BBC response to Ofcom's Consultation
“TV white spaces: approach to coexistence”

The BBC welcomes the opportunity to respond to Ofcom's consultation on TV white space coexistence, published on 6th September 2013 and with an addendum published on 24 October 2013.

Figure a1: The cumulative distribution of G

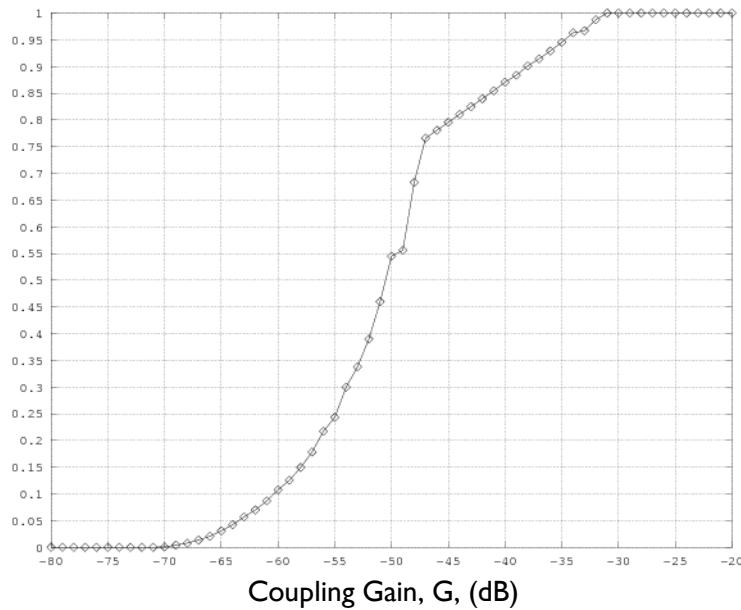
The cumulative distribution of the gain G is almost identical to that of Figure 4.10(a) and is shown as a reference in Figure a1. The 70th percentile for G is close to -47dB, which is in line with the value provided by Ofcom in table 4.1(a) (10m case, urban).

Figure a2: The cumulative distribution of r , $C=-60\text{dBm}$, $\Delta f=80\text{MHz}$

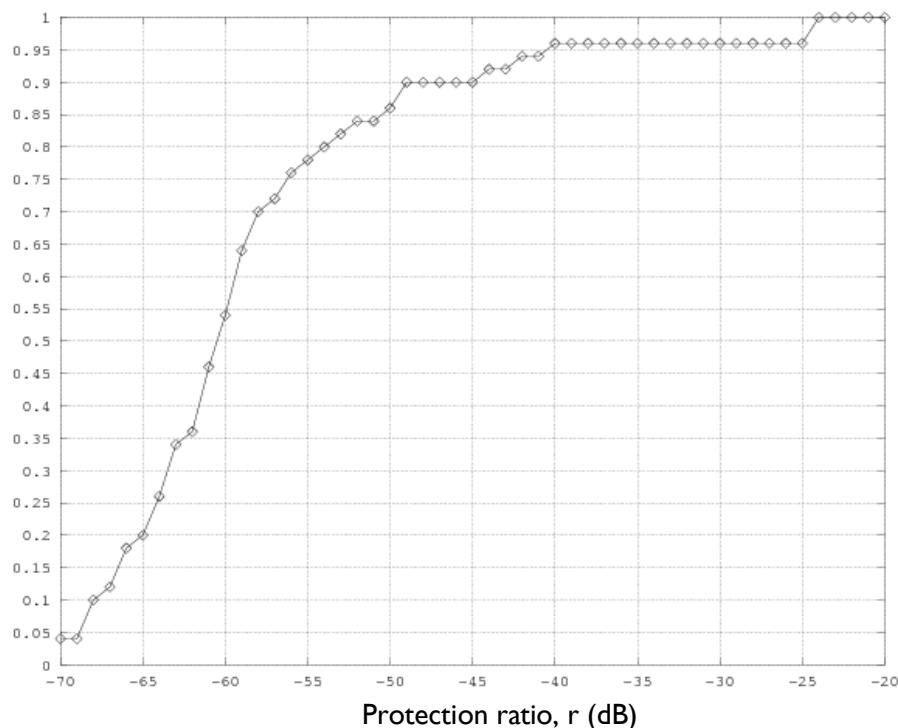
The protection ratios were taken from the last column of table A4.8 (p138). The CDF of the protection ratio r is shown below in Figure a2 below and the CDF of the combined distribution is shown below in figure a3. We can see that the 70th percentile for the protection ratio is close to -58dB, which is in line with Ofcom's value in table A4.16. Following Ofcom's proposal (paragraph 4.54), $r_T G_T$ should be $-47-58 = -105$ dB.

Figure a3: The cumulative distribution of rG , $C=-60\text{dBm}$, $\Delta f=80\text{MHz}$

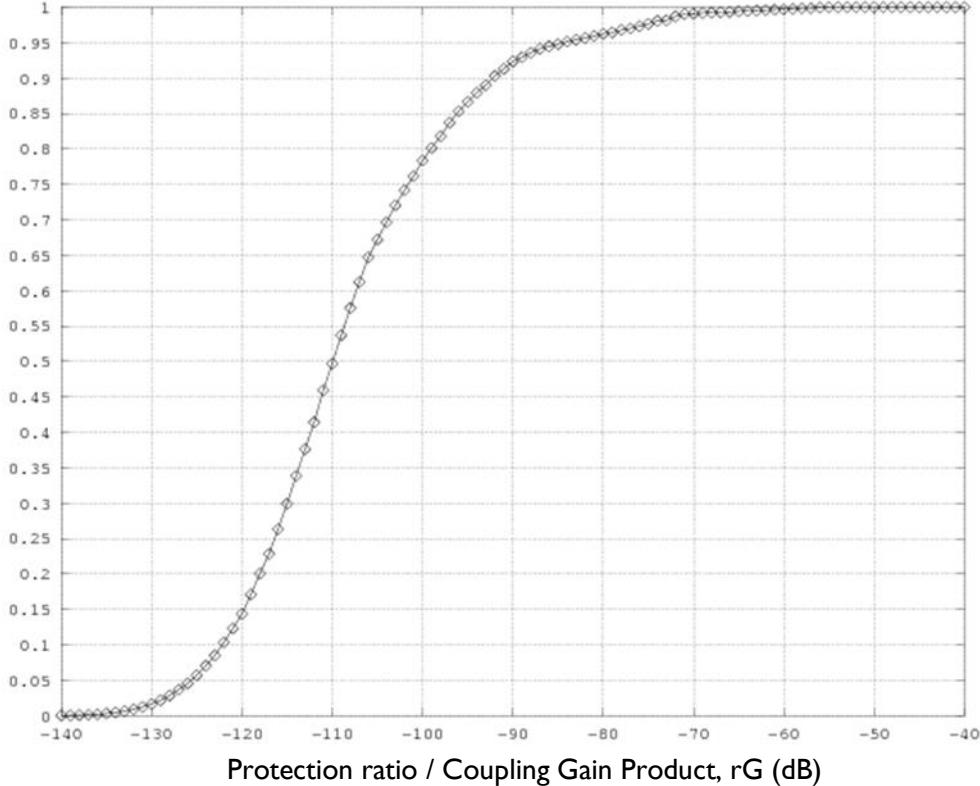
Figure a3 below shows the CDF of combined rG random variable. Looking up the -105dB value, we see that it is exceeded in 33% (rather than 10%) of the cases. The value that corresponds to the 90th percentile is -92dB, which will allow 13dB less WSD EIRP.

Figure a4: The cumulative distribution of r , $C=-60\text{dBm}$, $\Delta f = 8\text{MHz}$

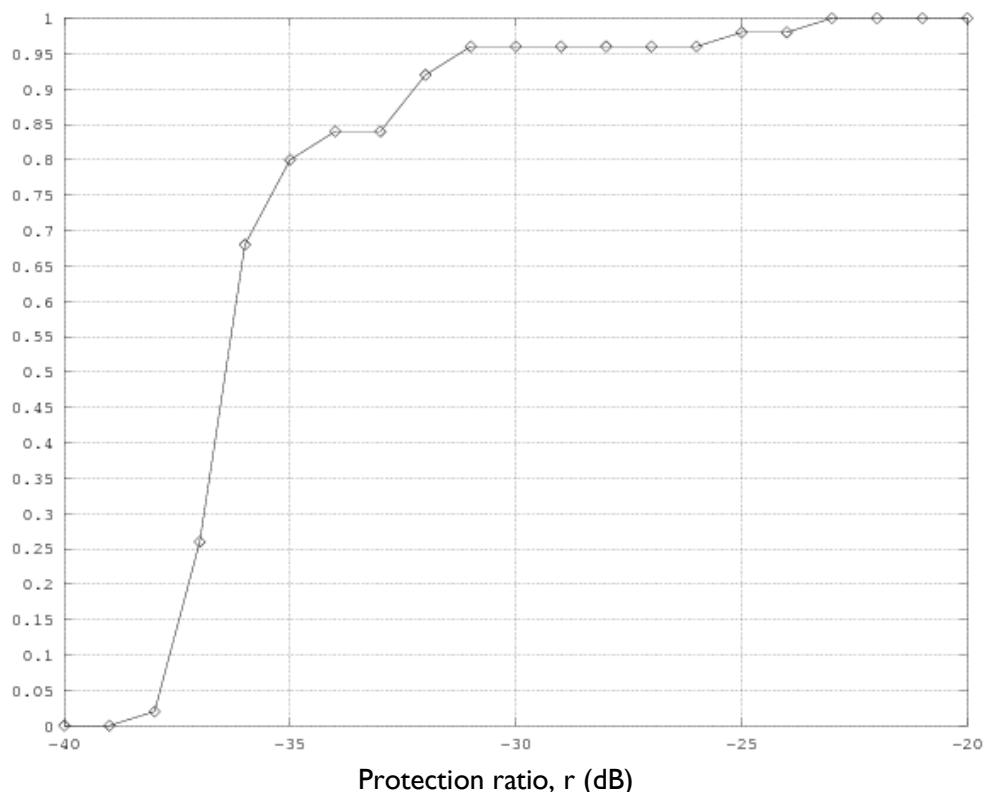
We present the CDF derived from table A4.8 in Figure C1. According to that figure, the 70th percentile is at -36dB therefore following eqn 4.5, $r_T G_T$ should be $-47-36 = -83\text{dB}$.

Figure a5: The cumulative distribution of rG , $C=-60\text{dBm}$, $\Delta f = 8\text{MHz}$

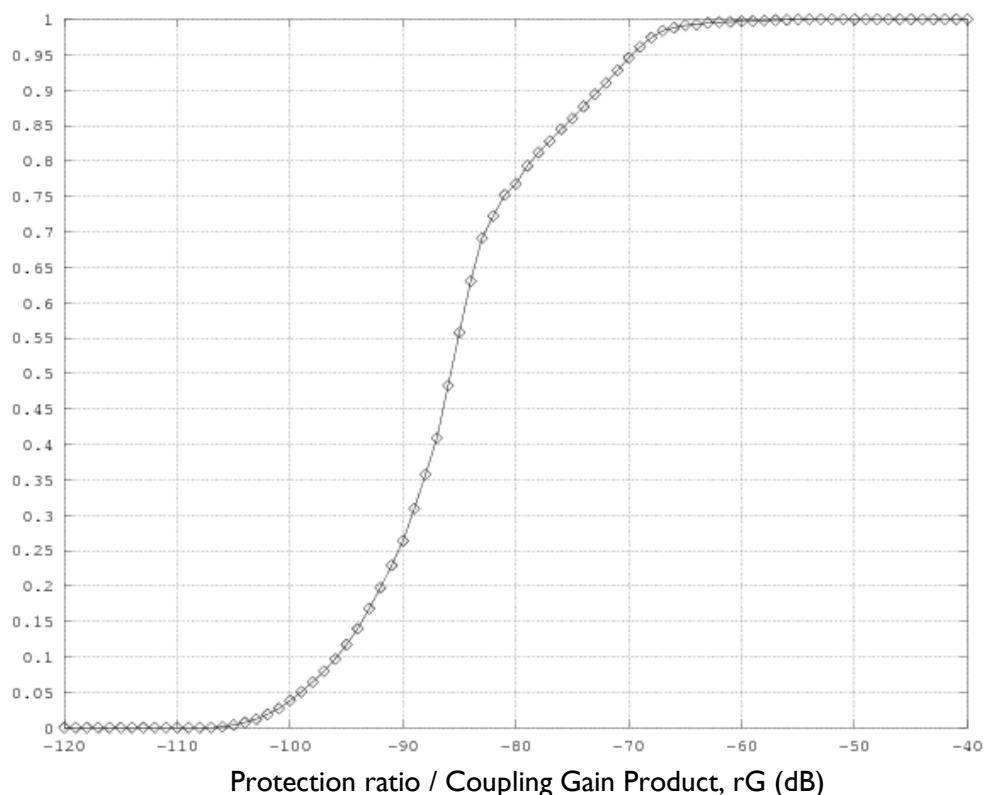
The CDF of the combined rG is shown in Figure a5. The -83dB value corresponds to the 69th percentile, so it is likely to be exceeded in 31% of the cases. The value which corresponds to the 90th percentile is -73dB which is 10dB higher.

Figure b1: Number of addresses compared with minimum distance to nearest neighbour

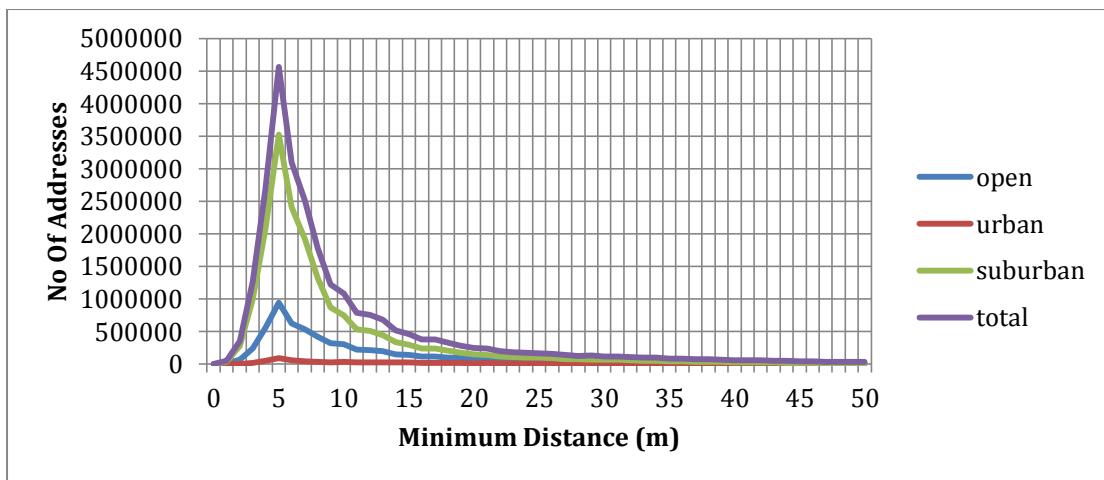
Figure b1 shows the number of addresses compared with the distance to the nearest neighbour. Most of the UK addresses are in areas classed as suburban, and the minimum separation is largely independent of the clutter type.

This research demonstrates that, by ignoring addresses that have a separation of less than 5m in urban areas, Ofcom is disregarding about 20% of total addresses. In the suburban and rural areas, however, this figure rises to approximately 75% of all addresses.

Figure b2 : Percentage of addresses conmpared with minimum distance to the nearest neighbour

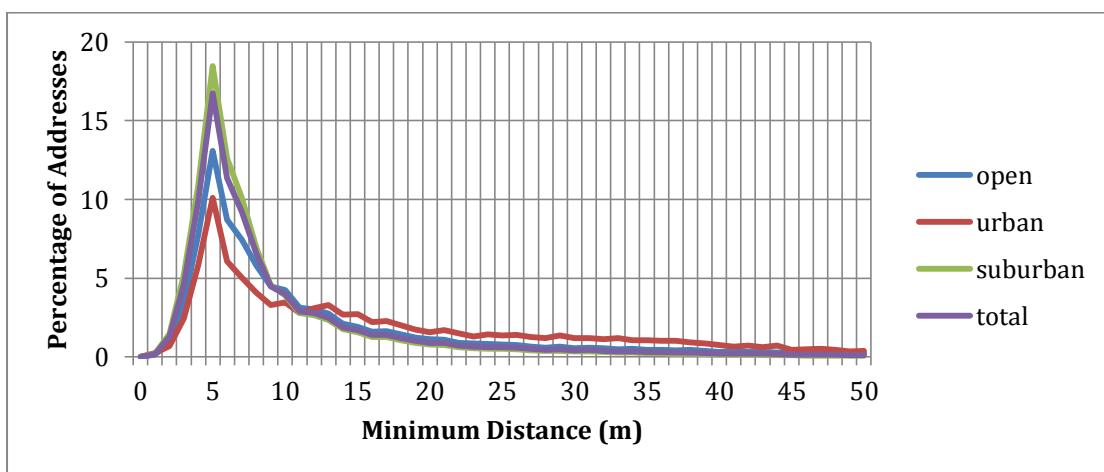
For further clarity, Figure b2 presents the same data in a normalised form as a percentage of the total addresses in each clutter category. The peak at 5m is clear in all cases. In urban environments, separations tend to be larger, but this may be explained by the presence of larger buildings in those areas.

Figure b3: Percentage of addresses that have at least one neighbour closer than the specified distance

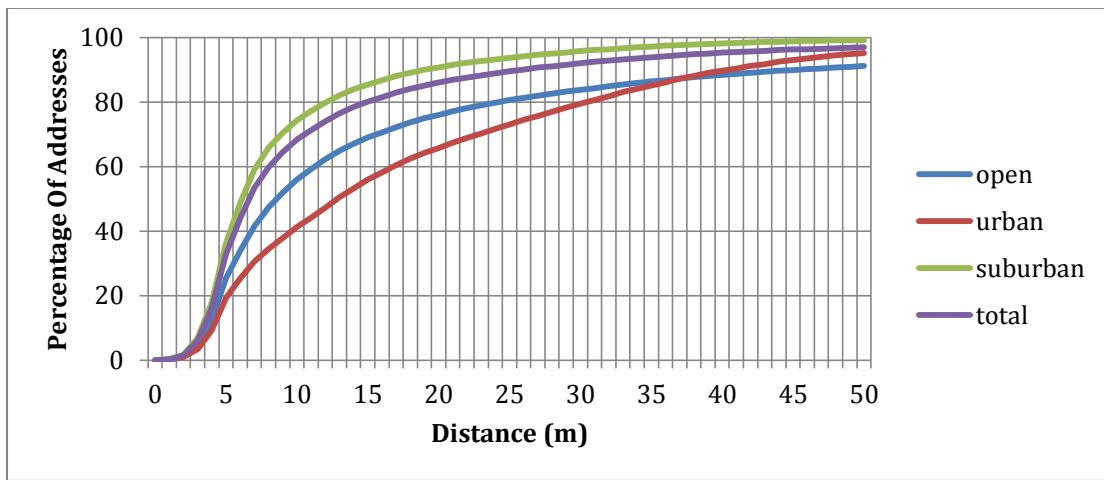
Finally Figure b3 shows the cumulative data, the percentage of addresses that have at least one neighbour at a distance closer than the abscissa.

Figure c2. Cumulative Distribution Function for Amplifier Input Intercept

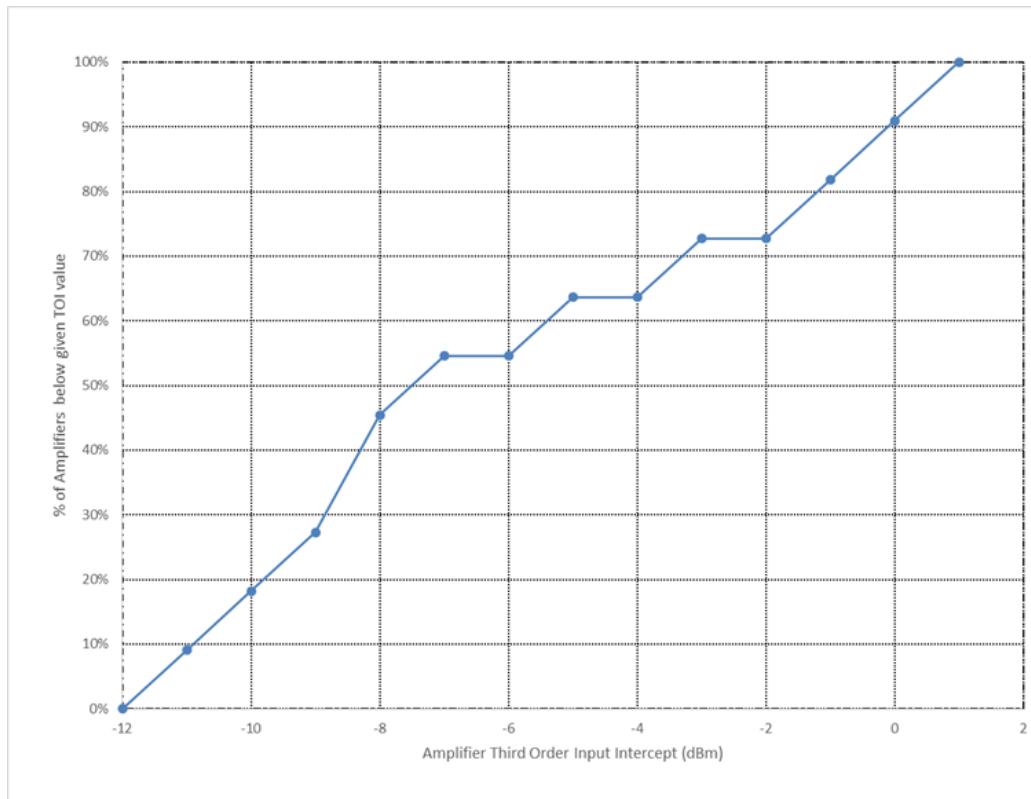
The 30th percentile input intercept is approximately -9dBm, suggesting that 70% of amplifiers will have a performance that exceeds this value.

Figure d1: The impact of WSD power levels on pixels in DPSA border areas

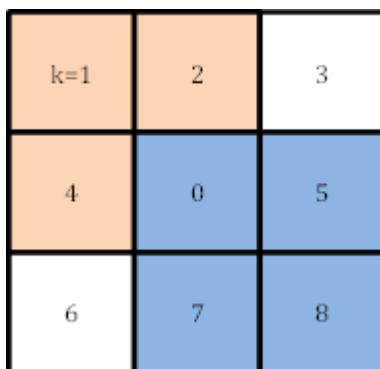
We will show that this approach can permit excessive WSD powers, especially in the border areas of two (or more) DPSA zones.

In the above figure, pixels with $k=1,2$ and 4 are in the DPSA of station A, which protects channel 21 and pixels with $k=5,7$ and 8 are in the DPSA of station B, which protects channel 41. The WSD is located in pixel 0. Pixels 3 and 6 are not populated, hence ignored.
